Major Drainageway Infrastructure Alternatives - Walton Creek
Citywide Stormwater Master Plan
Steamboat Springs, Colorado

APPENDIX D –CORRESPONDENCE

Steamboat Springs Stormwater Master Plan

Denotes replacement due to condition, not capacity
 Denotes existing pipe capacity is sufficient to convey future 100-year flows
 Denotes flow greater than pipe capacity

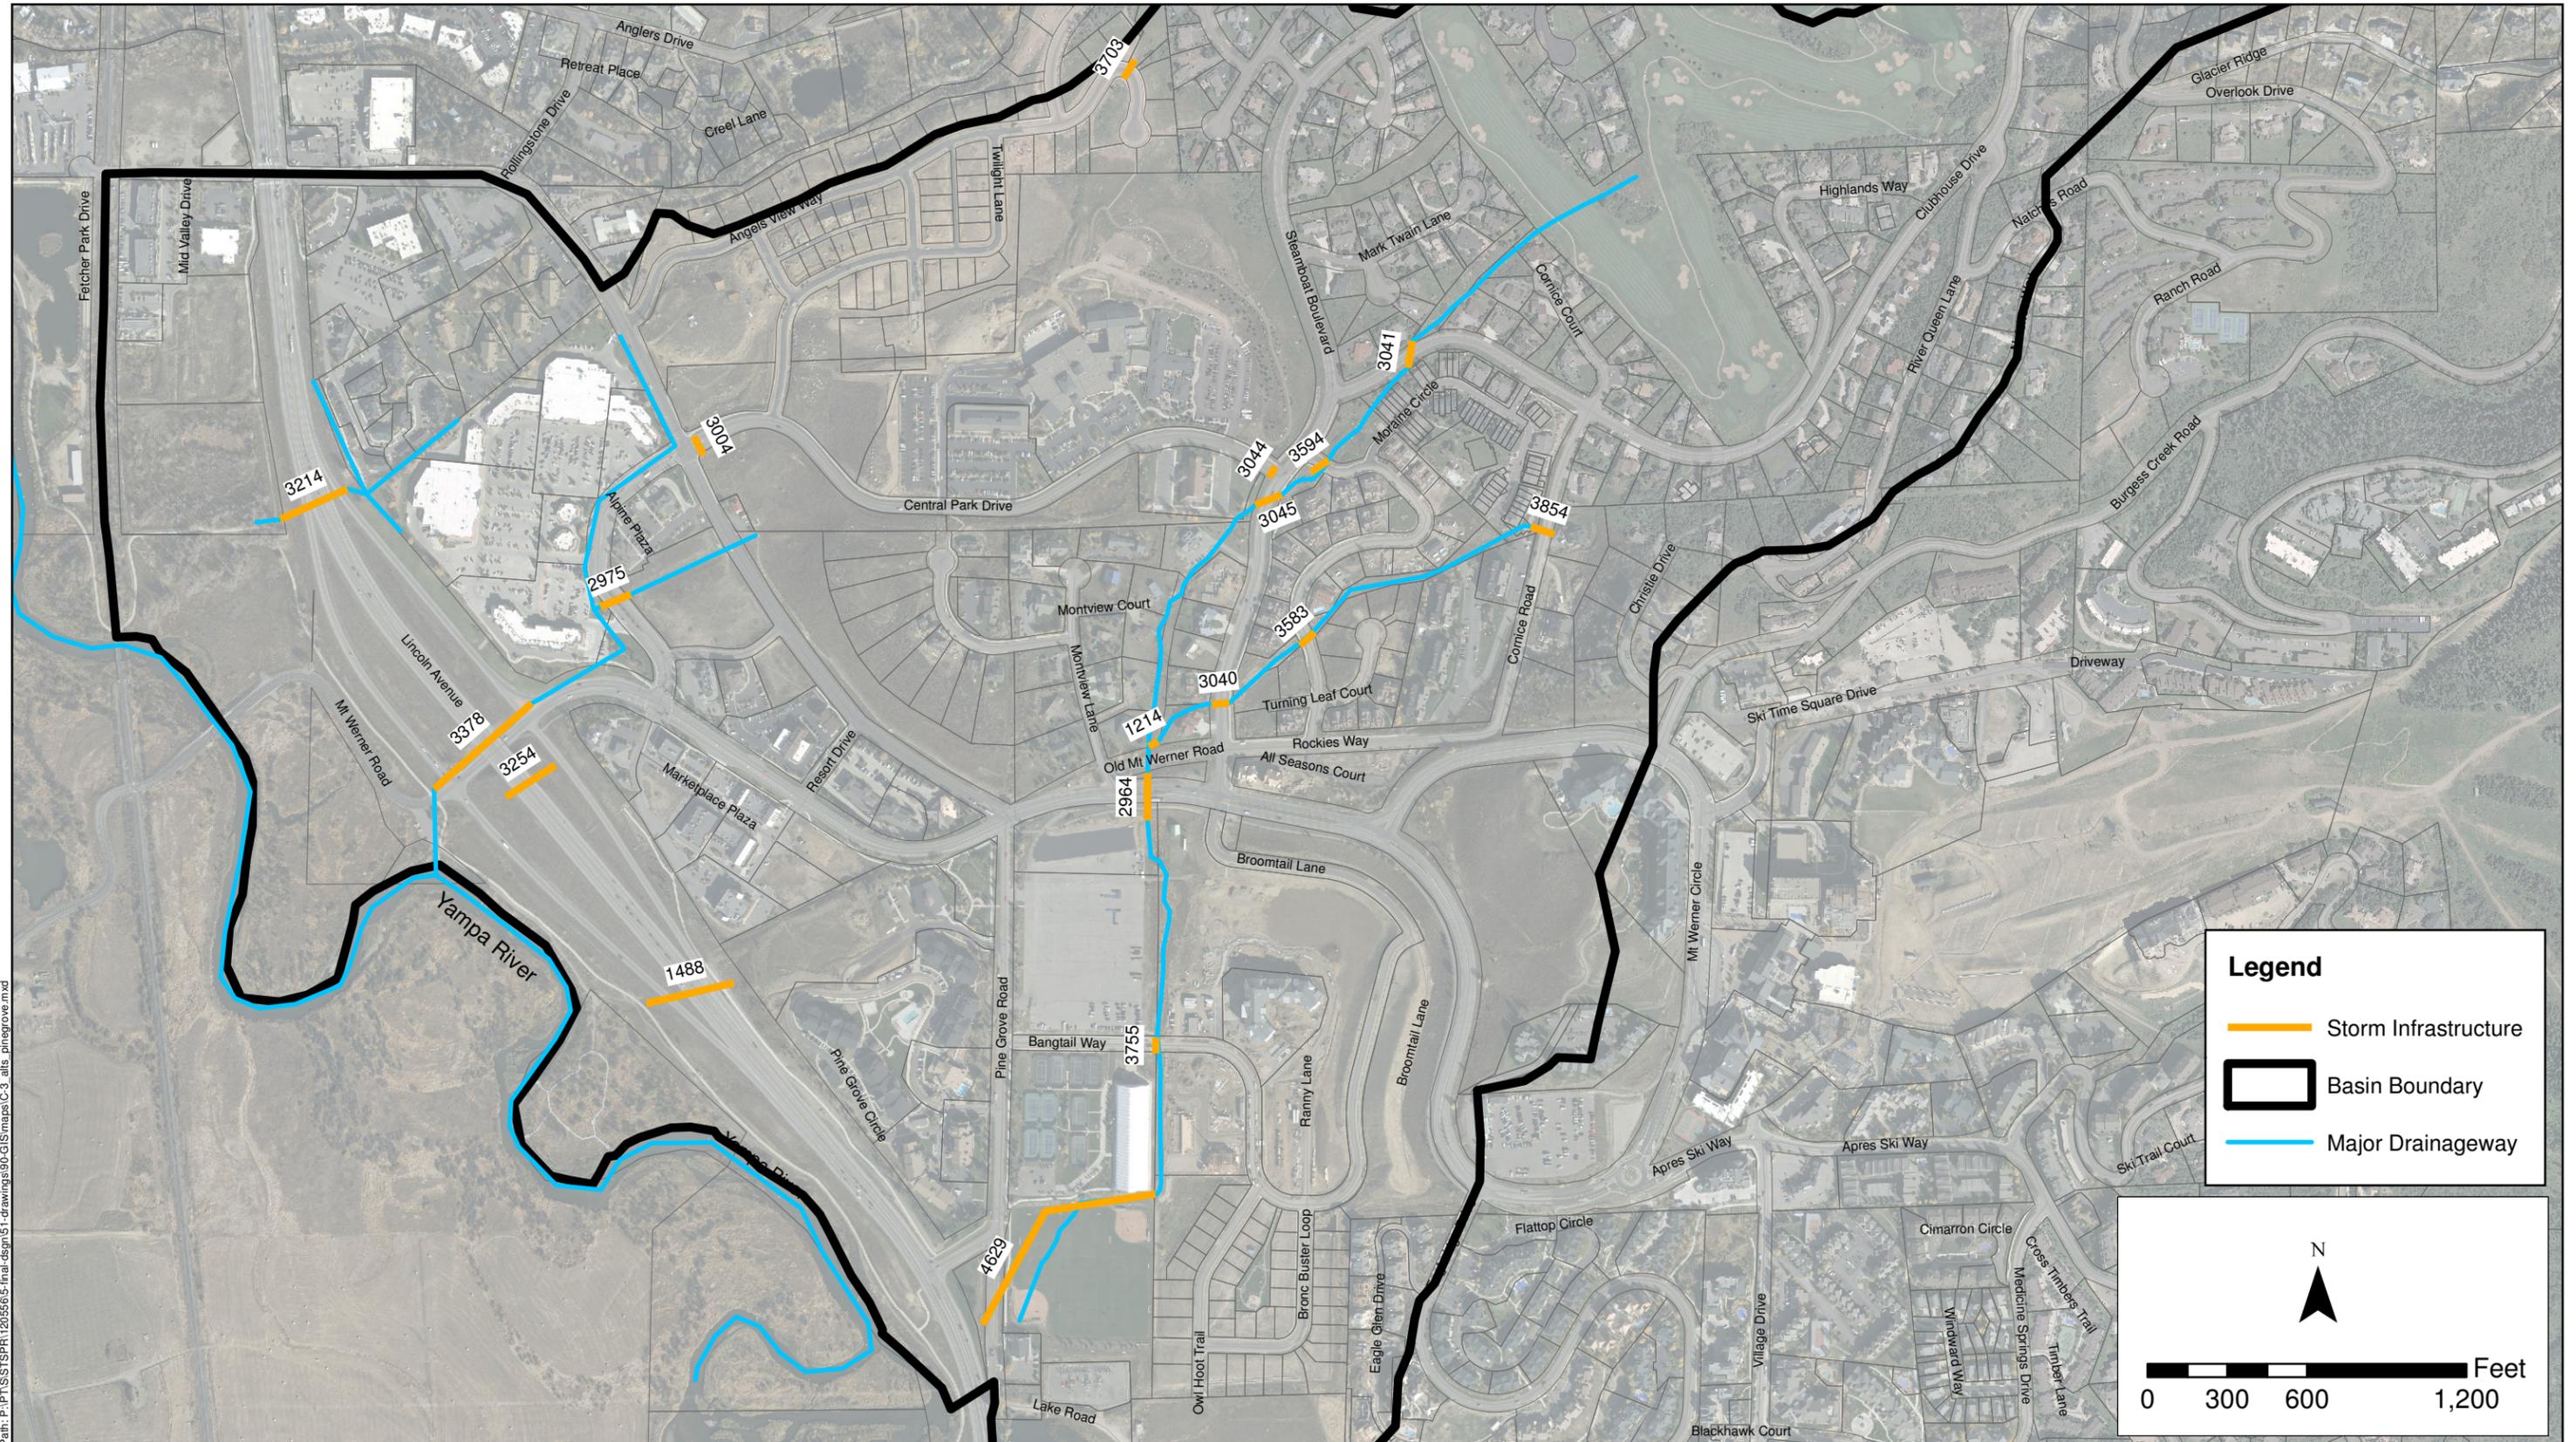
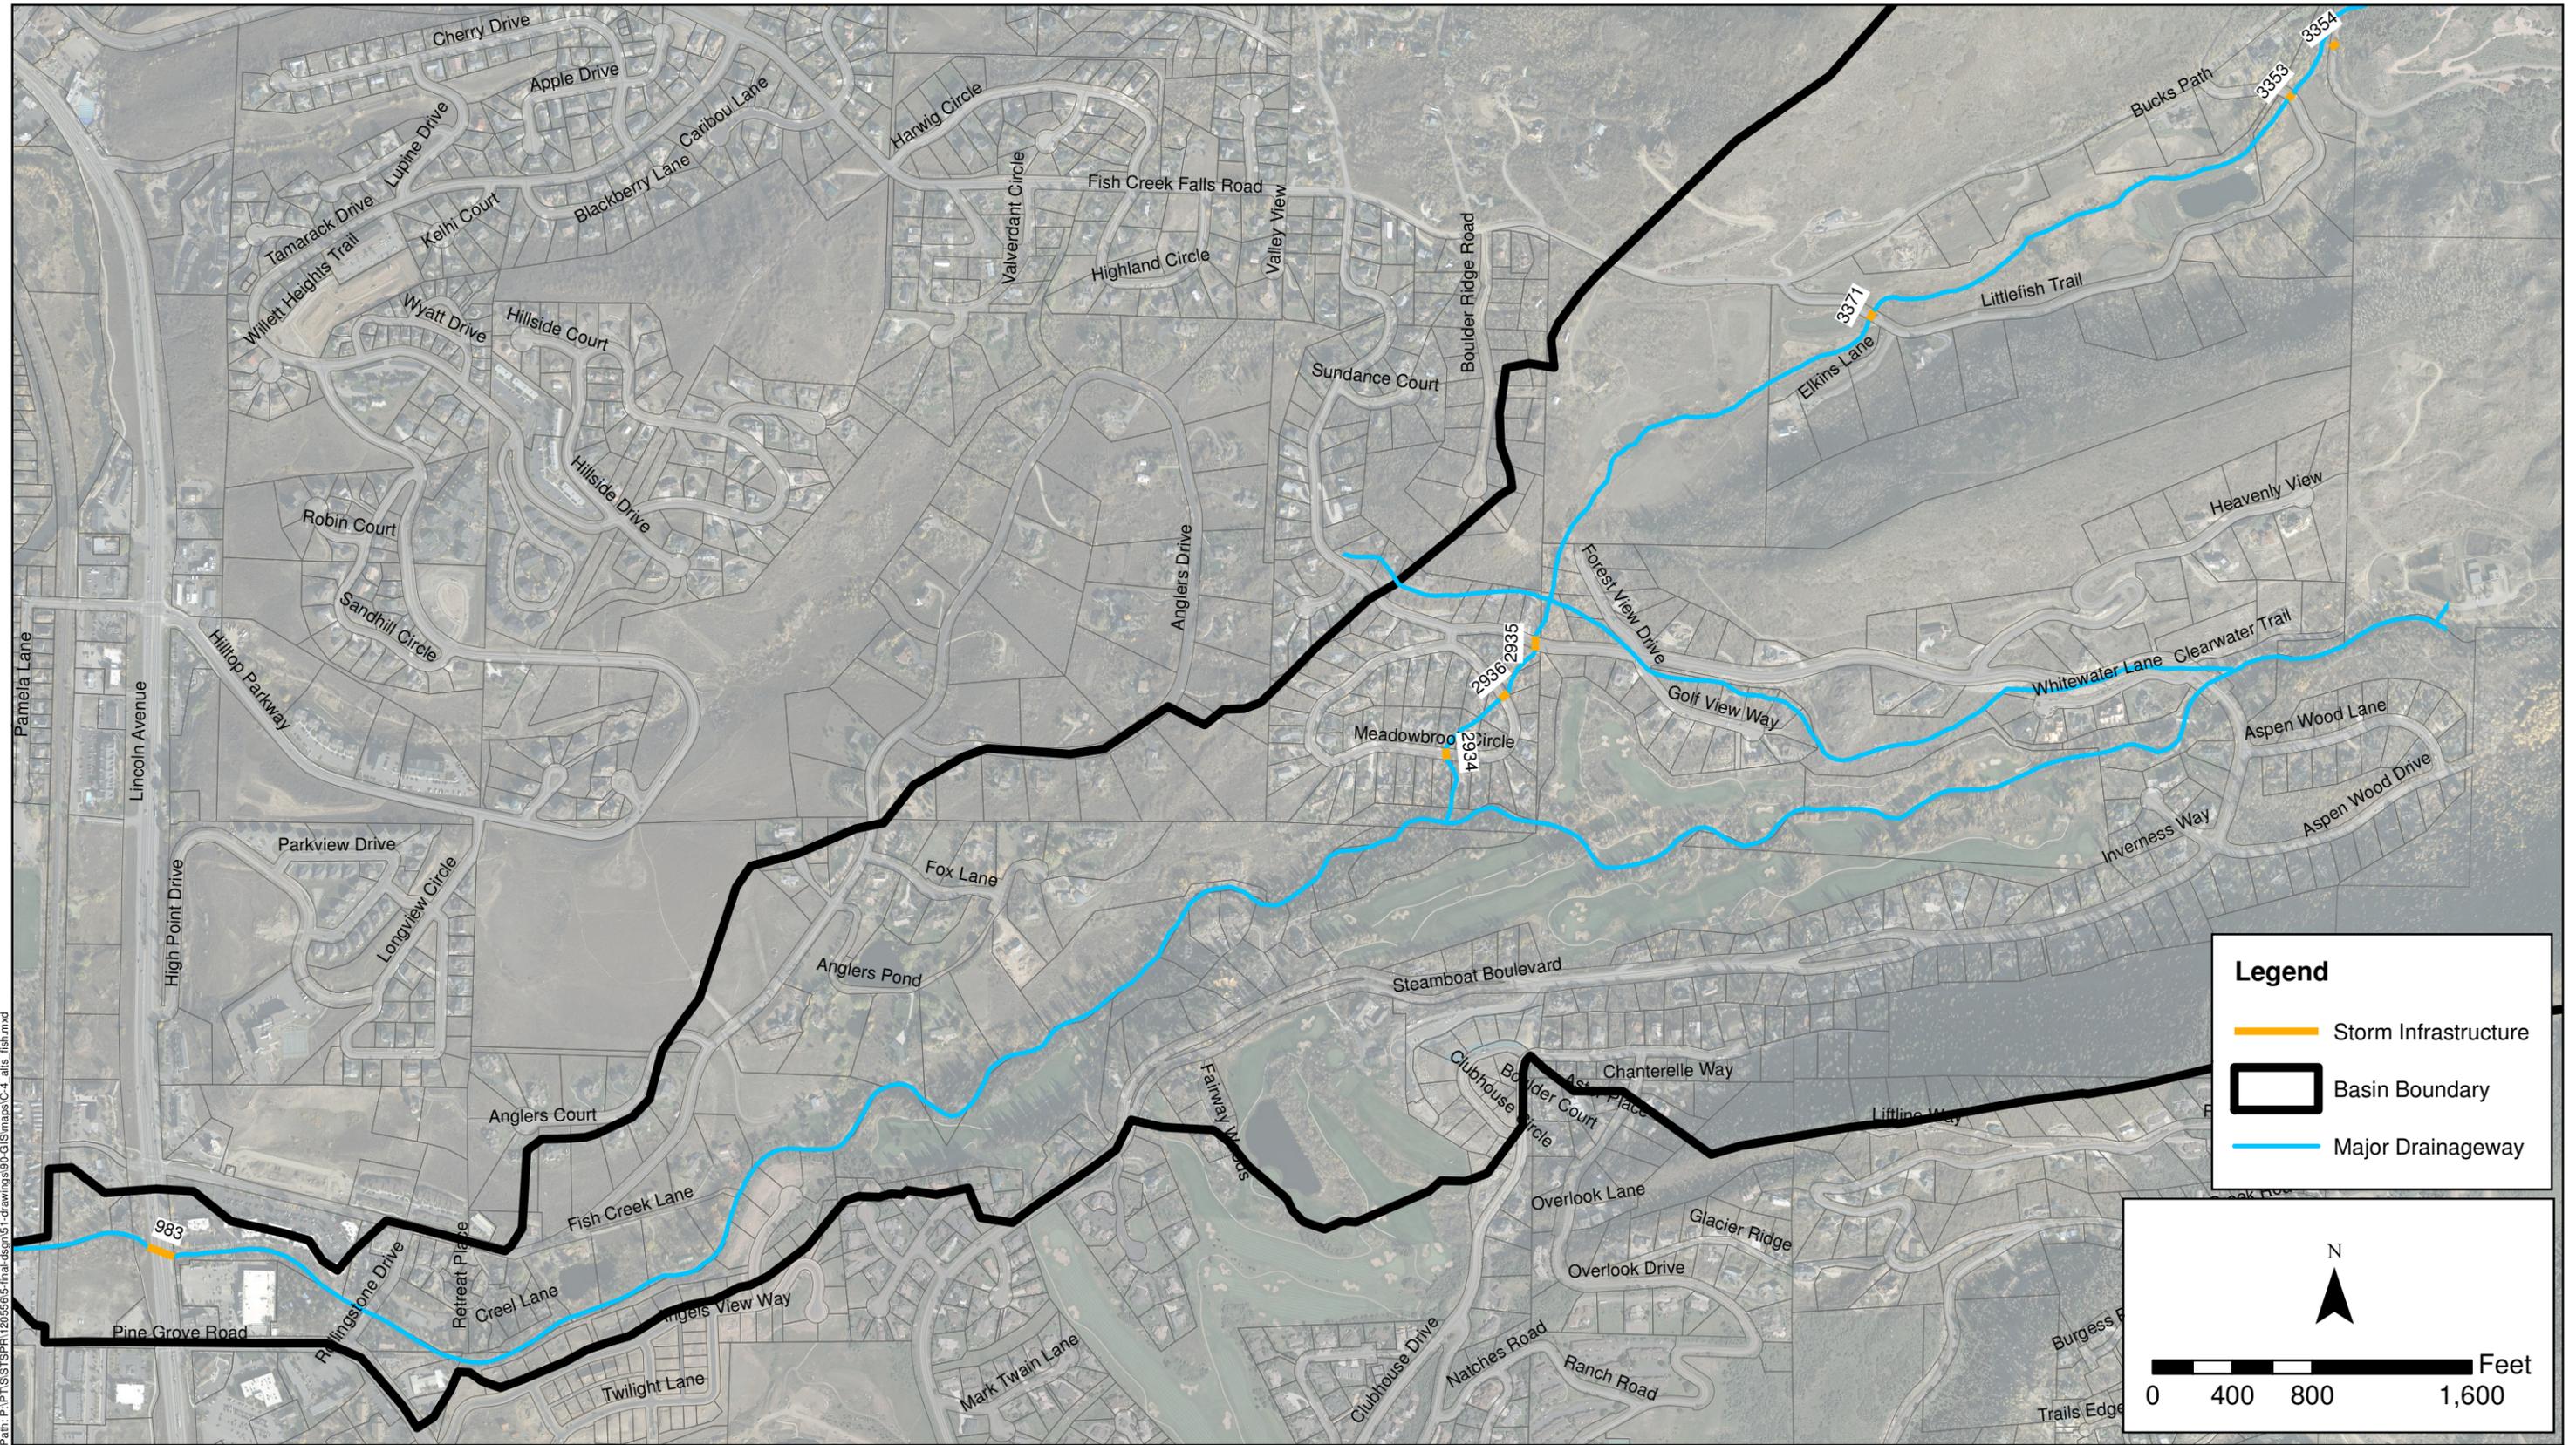
Ben Beall	Please add the culvert ID# as shown on the Problems and Needs Maps with the recommendations shown in the Alternatives Analysis in Appendix C.	The culvert ID# has been added to the spreadsheets in Appendix C for easier cross referencing.
Ben Beall	In 2.2.10, you describe EM/ORM as slightly larger than 2 acres. Is this a typo? Should it read "2 square miles?"	Yes, the EM/ORM basin is just over 2 square miles in size.
Ben Beall	You list in the Problems and Needs written section that the drainage at Skyview Lane should be addressed, yet there is no graphic representation of this on the Problems and Needs map. What needs to be done at this intersection? This location was specifically identified as a problem drainage location at the May 15th kickoff meeting. The required improvements and estimated cost should also be captured in Table C-1 when that is complete and the reference numbers are included. In Table C-1 you show that there are 3 36" existing CMP. There are only 2 that cross under Whistler, plus a third smaller culvert.	The east roadside swale/ditch for Whistler Road does not have sufficient capacity to convey flows, and backs up onto the street. Twin 36-inch CMPs carry flow beneath Whistler Road to the north roadside swale/ditch for Skyview Lane. The 3rd, smaller culvert is non-functional according to City staff. Redevelopment of the northwest corner of this intersection includes a proposal to convey part of the flows to the south roadside swale/ditch of Skyview Lane.

Ben Beall	It does not appear that the recommendations on the Problems and Needs Map match the recommendations on the Alternatives Analysis. For example, for Burgess Creek at Stonecreek Court on the P/N map, you show clearing the culvert to restore capacity (#25 and #26) and in the Alternatives Analysis you show replacing with a 66" RCP (#1336). That means that we are assigning a replacement cost to the overall numbers when you are recommending immediate maintenance only elsewhere. It appears that the alternative analysis sizes ALL culverts to convey the 100-year flow. The City Drainage Criteria does not require this of all culverts. It requires 100yr capacity for all collector and arterial roads and 5yr capacity for all others. We discussed this at length in progress meetings. Why are you including costs to replace culverts that meet current City Drainage criteria?	We recommend clearing culverts to restore capacity in every case where we observed clogged culverts in the field. Clearing clogged culverts optimizes the existing stormwater conveyance system. The existing culvert at Stonecreek Court at Burgess Creek needs to be replaced to convey the 100-year storm event. We used the 100-year storm event because the 100-year event is an engineering standard, and to be conservative for stormwater funding purposes. Because this is a conceptual-level report for stormwater funding purposes, we agreed to use the 100-year storm event for modeling purposes. When more detailed outfall systems planning studies are performed on a basin-by-basin basis, more scrutiny can be applied to individual issues, problems, and needs.
